## **Submission to Eastern Freeway UDLP Burke Rd to Tram Rd (Peter Carter)**

I acknowledge the opportunity to provide comment on the Eastern Freeway Upgrades Urban Design and Landscape Plan: Burke Road to Tram Rd

Figure 1. NELA proposed SUP overpass (red) on the eastern side of Bulleen Rd

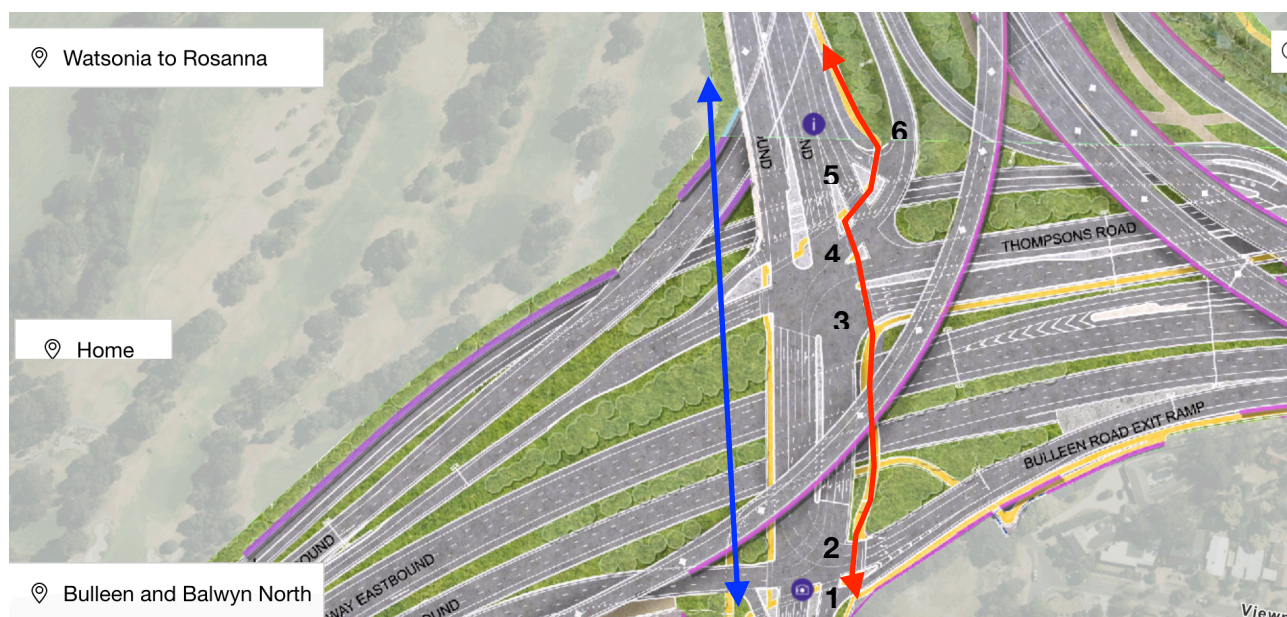
Through this complexity cyclists and pedestrians have to negotiate a dangerous intersection environment. Any independent road safety auditor would rate this intersection low in respect to being safe for pedestrians or cyclists. Users will likely experience long signal cycle delays with the most pedestrians and cyclists crossing to use the SUP overpass on the eastern side. Refer Figure 1

**It is requested that the Shared User Path overpass bridge of the Eastern Freeway be located on the western side of Bulleen Rd.** As an alternative, the western footpath is approximately 2.6m; however it is reasonably straightforward to widen the footpath on the western side (by a slight reduction in the median) Pedestrians and cyclists will be have a more direct and safer access to the Veneto Club plus access to ovals and the Bolin Bolin billabong on the western side.

Yet this route crosses 6 roadways that all have traffic signals; the roadways 3, 4, 5 and 6 would be particularly dangerous to cross despite signals.

Overall this proposed route would likely take over 5 minutes (because there would be a minimum of two traffic signal cycles for this trip)

The perceived danger plus the time to do the crossing, would deter many cyclists; other more confident cyclists would likely directly ride on road.

**A much safer and more appealing route for all cyclists, is to have the SUP overpass on the western side (blue) of Bulleen Road.**

Figure 2, Above: the redundant third exit lane shown in black

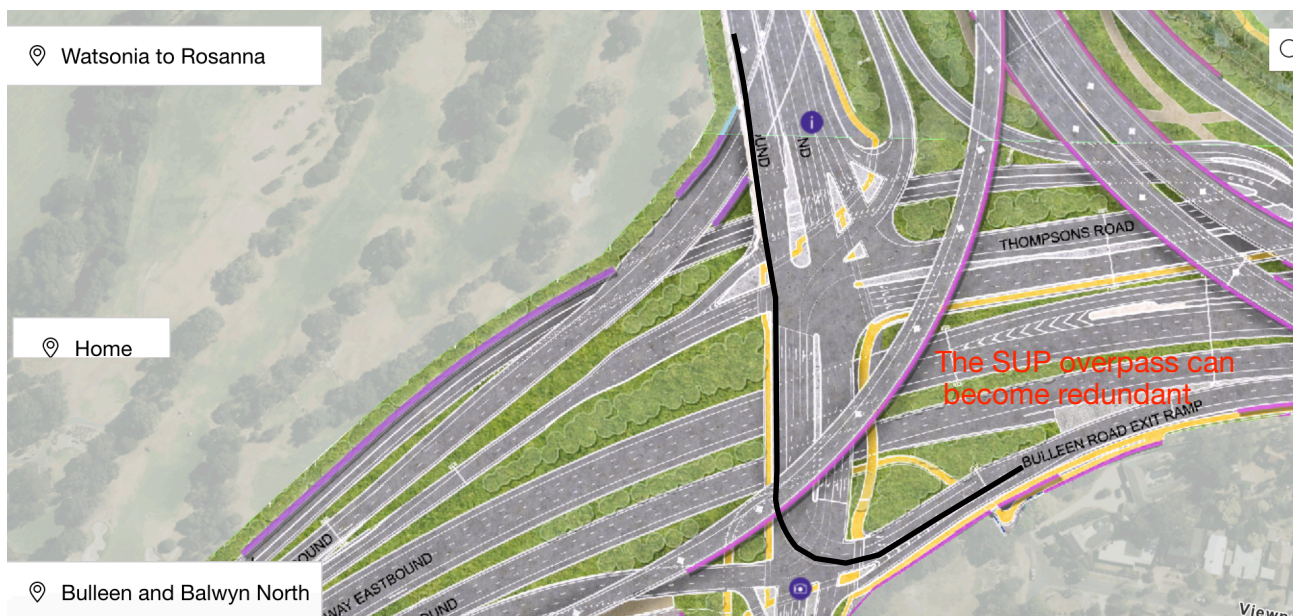
A most questionable aspect is why Bulleen Rd overpass **still needs** to have three lanes turning north from the exit ramp to Bulleen Road. This is more lanes than provided for the Eastern Freeway to North East Link ramp. Does the east to north movement really need 5 lanes (ie 3 in Bulleen Rd and 2 lanes on the fwy-fwy ramp)

Removing one of the three north bound through lanes on the overpass would allow separated bike lanes on the western side of the Bulleen Rd overpass; or alternatively having wider footpaths on each side of the overpass. Refer Figure 2

Furthermore the separate SUP overpass Bridge proposed on the eastern side of Bulleen Rd would be redundant. And the complexity of accessing this overpass is obviously gone!

The existing third lane is apparently 3.4m wide; realigning lanes on Bulleen Rd overpass would enable footpaths of approximately 4m to be provided on both sides of the bridge.

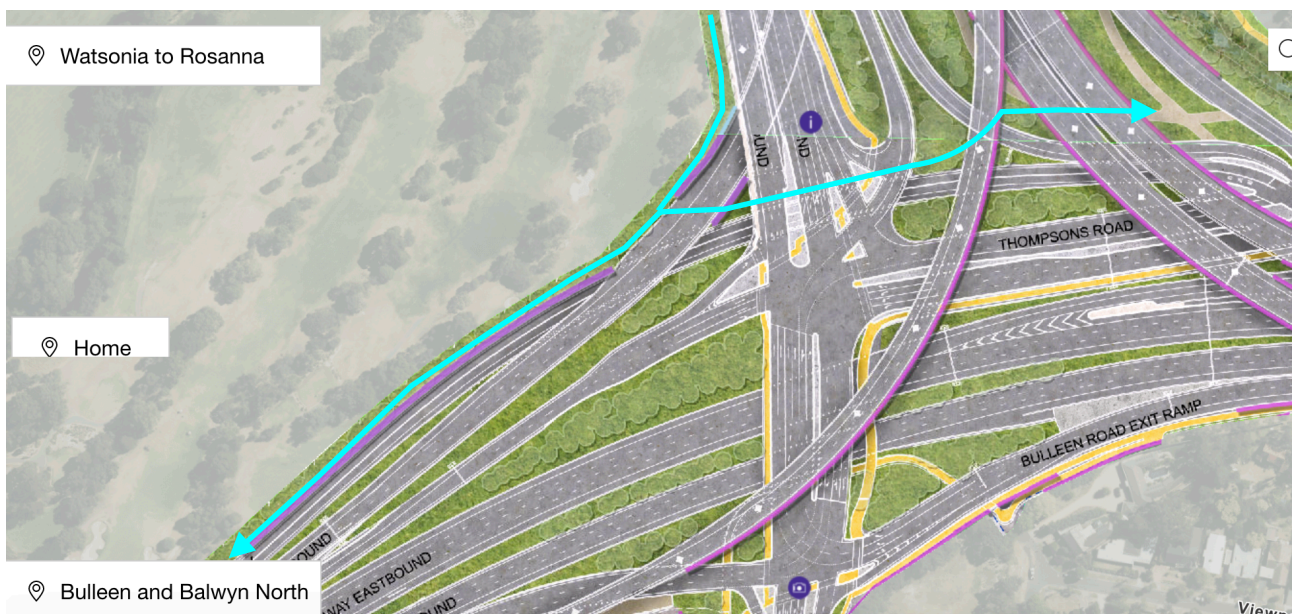
**The Bus Expressway under Bulleen Road; Widen the bus expressway culvert to include a pedestrian and cycling path on the north side of the bus expressway.**

Why would you NOT provide for pedestrian and cycle access?

It is requested that the underpass for the bus expressway also provides for pedestrians and cyclists (similar to Doncaster Rd).

Figure 4

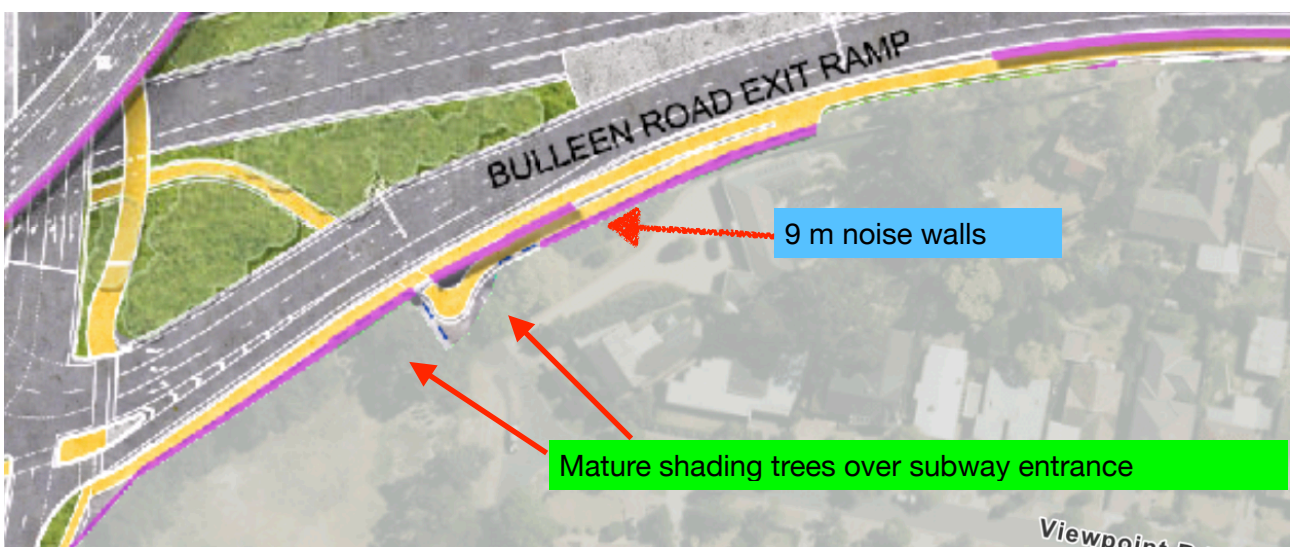
To access this underpass pedestrians and cyclists must diverge from the main KCT via a very narrow path to Highview Rd (behind Bell View Primary School)

On one side there's a private property with mature shady trees shading over this path as well as a 9m noise wall. The other side will have a 9m high noise wall. It becomes a very DARK place, unlikely to have any sun.

Regardless of whether this noise wall is part concrete/acrylic or glass, the KCT path exit to Highview Rd and into the exit ramp SUP underpass, significantly lacks personal safety amenity.

In addition there is a significant lack of visibility of users (pedestrians or cyclists) emerging from the SUP from Highview Road onto the main Koonung Creek Trail

This whole concept is flawed; NELA needs to have significant redesign to make it acceptable to all potential users.

Revisit this whole area and make a direct SUP underpass of Bulleen Rd.

Figure 5: Layout and elevation plans for the proposed Doncaster Rd overpass, with no consideration for connections of the Principal Bicycle Network Routes

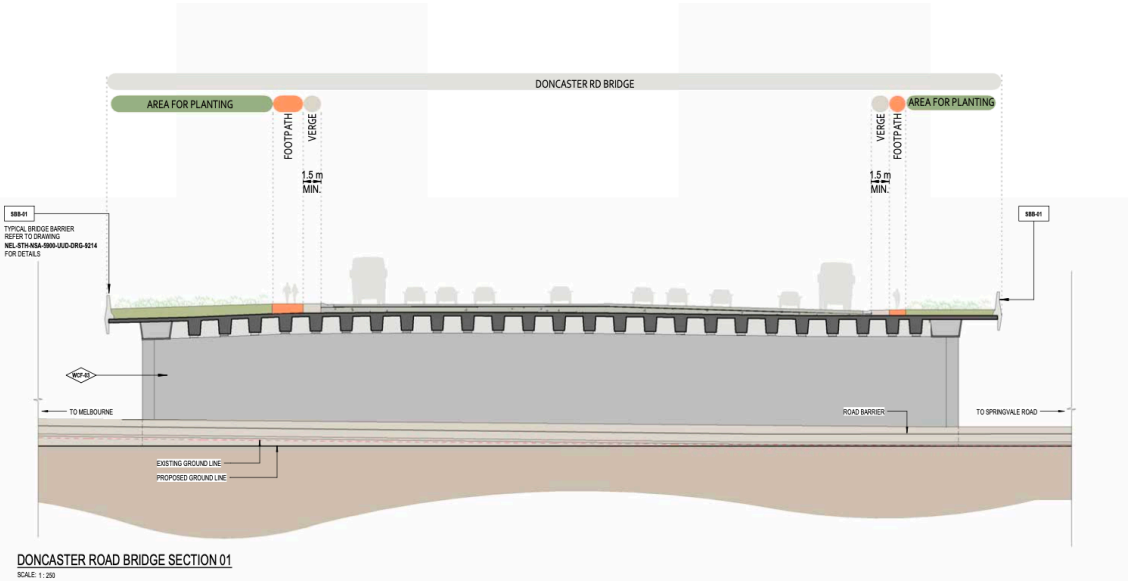
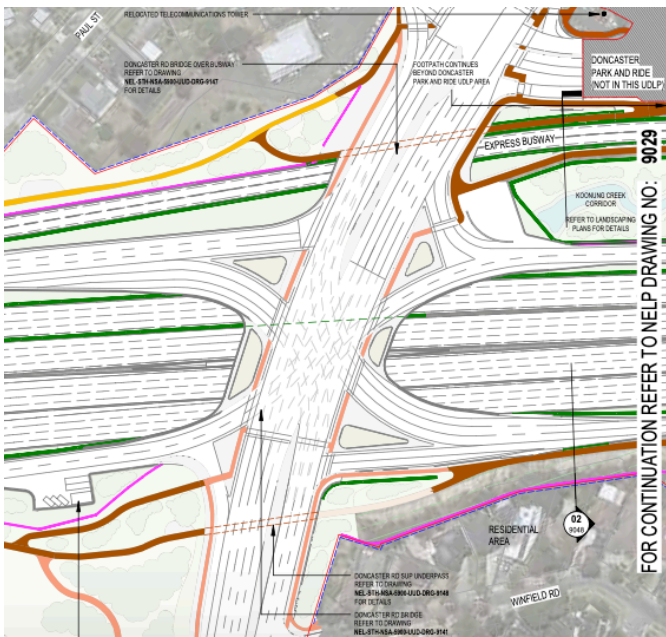
Other footpaths are described as secondary paths - the eastern footpath over the overpass appears to be 1.5 m wide (which is not DDA compliant; totally inappropriate given the proximity to Doncaster Park and Ride) The western footpath on the overpass is slightly wider, about 2 to 2.5m (refer cross-section Plan 9145)

The Doncaster Rd Overpass is a very long term investment. It is too dangerous to expect cyclists to ride over the overpass sharing vehicle lanes, and with the complexity of various turning traffic movements.

The NEL needs to provide separated bicycle lanes on the overpass that connect to Doncaster Rd on either side, and to High St.

A further consideration; the proposed interchange arrangement is likely that pedestrians coming to/from the Doncaster Park and Ride will have to experience long delays (two signal cycles or around 5 minutes) crossing using the footpaths on the eastern side of the overpass. It may be even longer to cross on the western (city) side .

Figure 6: Heyington Bridge. Two options that avoid the swithback and the disastrous intersection with the KCT

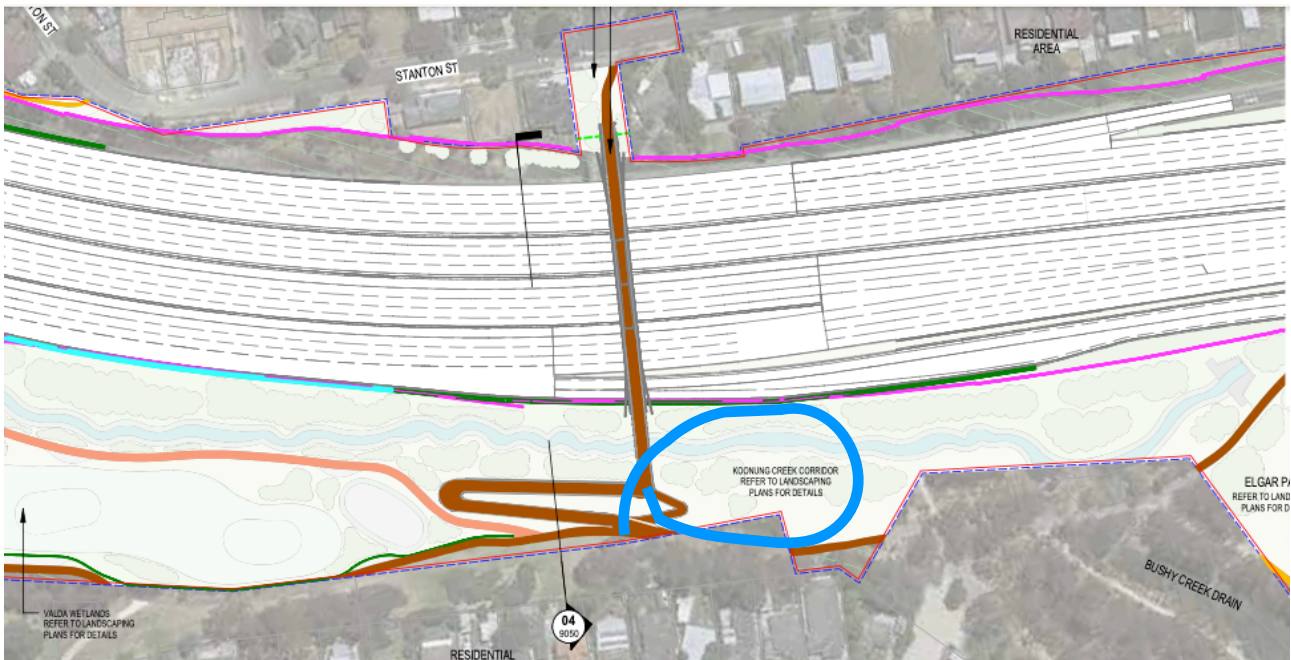
On its southern end the ramps extend over the wetlands, at a height about 6m above natural surface. This needs to have a ramp length of approximately 120 m to the KCT to be DDA compliant.

The UDLP design shows a switchback then a very acute intersection of the ramp with the KCT. Just how a designer could contemplate that any cyclist be able safely negotiate that intersection if going to /or coming from the city side.

The use of switchbacks should be avoided; generally only the very experienced cyclists can retain balance to make the turn; others will lose their balance, particularly families with young children riding. (tandem cyclists, or cyclists with trailers, or tag-along child carriers inevitably have to stop and haul their bikes around)

- a) provide long straight ramps from both directions
- b) a spiral ramp (approximately 30 m diameter)

The required length of ramp to be DDA compliant is about 120 metres.

The top suggestion - the 'green V' allows approach from both directions (each having a safe intersection with the KCT path. Both ramps final orientation would need more detail design to locate piers in respect to waterways

The bottom suggestion - blue spiral, is similar to that NELA has proposed at Lwr Plenty Rd. Again positioning of the spiral - left, right or middle requires further detail design.

Figure 7. Widen footprint for path to improve amenity and sight distance; reduce adverse gradient

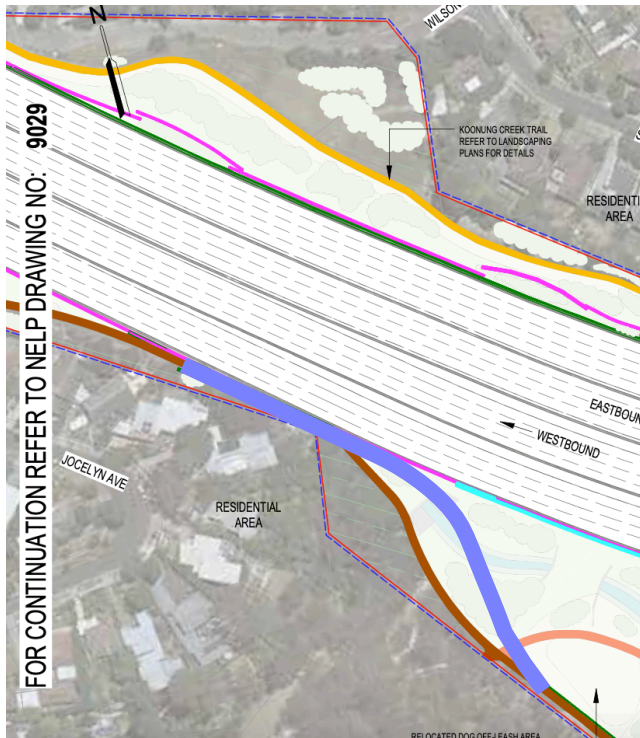
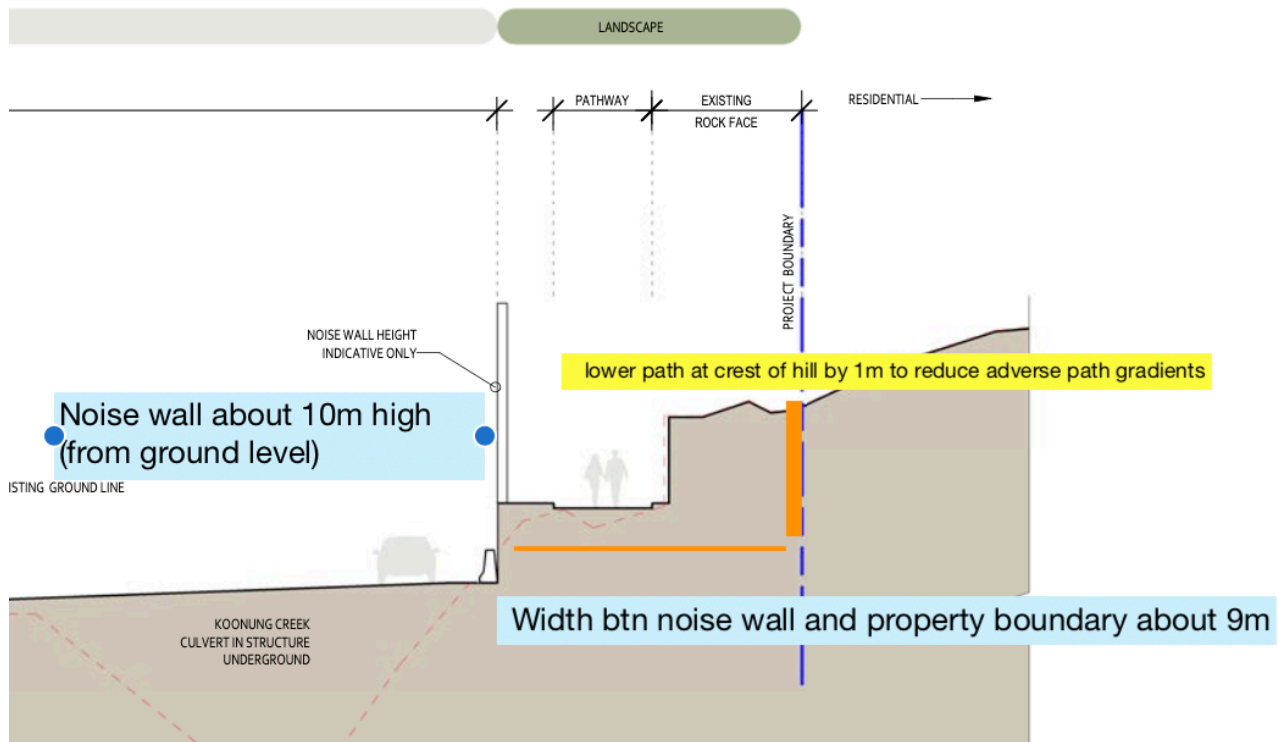
The proposed NEL works involve significant widening of the freeway and installing a 10 m Noise Wall at the pinch point - the top of the crest, extending to the above-mentioned corner.

So at this location there will be the rock retaining wall at the top and south side of the path, and then the 10m noise wall. The residual gap is around 3.5m.

Personal safety amenity? It simply will NOT exist.

But it can be readily addressed. The path can be widened, with relocation of the retaining wall on the south side of the path to the property boundary, plus reducing the gradient by lowering the crest in the KCT. The KCT requires a realignment on the eastern end to improve sight distance. Refer Figure 7

Re-align SUP to avoid blind spot at corner

Figure 8

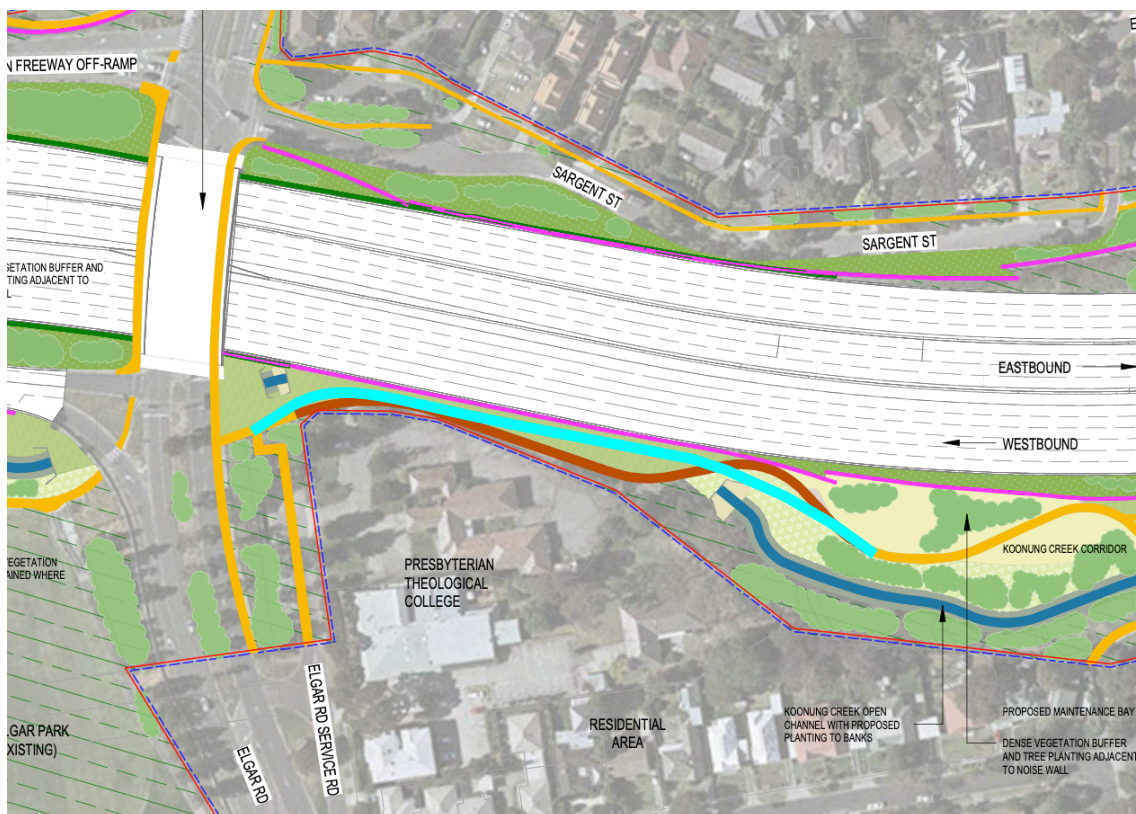
To the east of Elgar Rd, the UDLP shows the widened Eastern Freeway significantly constraining the existing space. The widening has required the existing Koonung Ck culvert to be extended further upstream.

A 10m noise wall is proposed immediately to the north side of the KCT; on the south side of the path is the property boundary fence of the adjacent Presbyterian Theological College. (It is considered likely that with further development, that this property will have a high fence constructed on its northern boundary.)

The sight distance on the path is currently limited, and will diminish further.

It requested that the KCT is realigned to improve sight distance, within this constrained environment. Refer Figure 8
